Cordillera Valley Club

Design Review Board Application Form

Name of Project: 1611 Beard Creek Trail

1611 BEARD CREEK TRAIL – MODIFICATIONS TO APPROVED PLANS
PROJECT #1943

C1.0

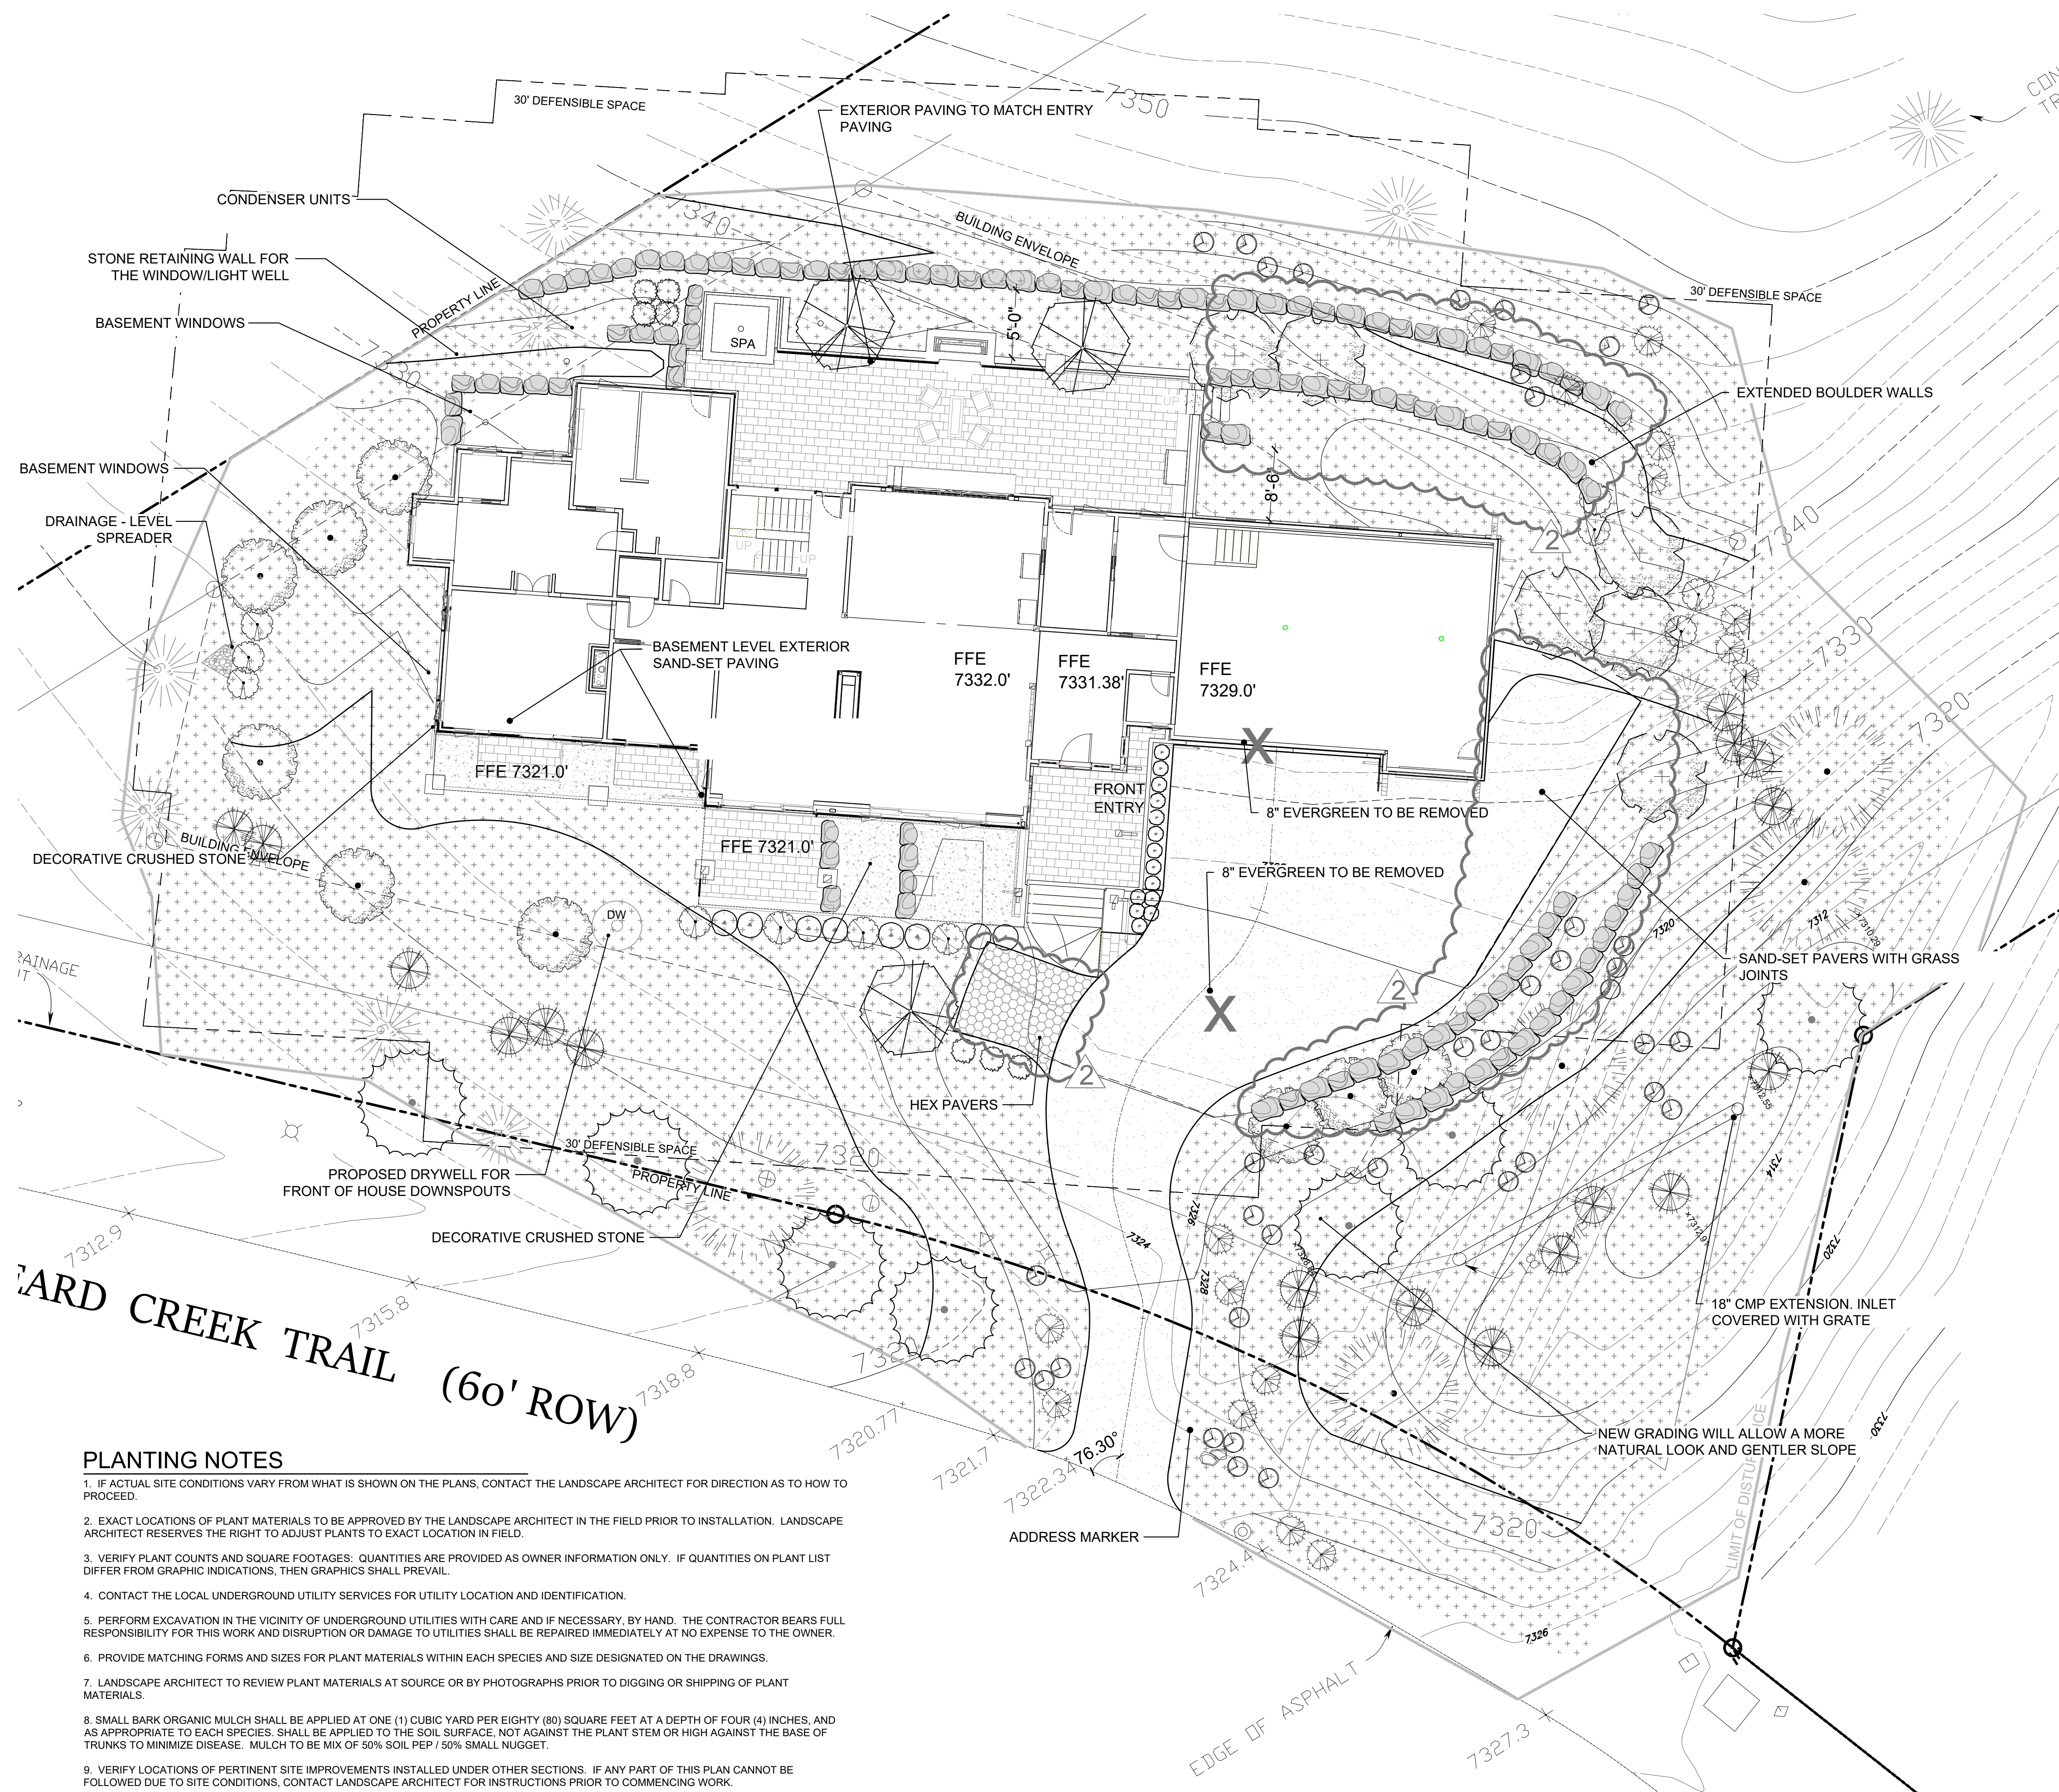
- Clouded revisions on sheet C1.0 & L3.0 submitted for DRC record.
SRI & Pinon Sage have further reviewed the driveway area required for safe and effective vehicle access in and out of the garages. The modified boulder walls with eased radius to better relate with existing site conditions, driveway slope and adjusted to better follow the building envelop east/southeast edge of driveway. The modification reduces the elements previously extending into steeper existing slopes that required more excess fill which is not desired. We feel these modifications will allow owners to safely navigate the driveway.
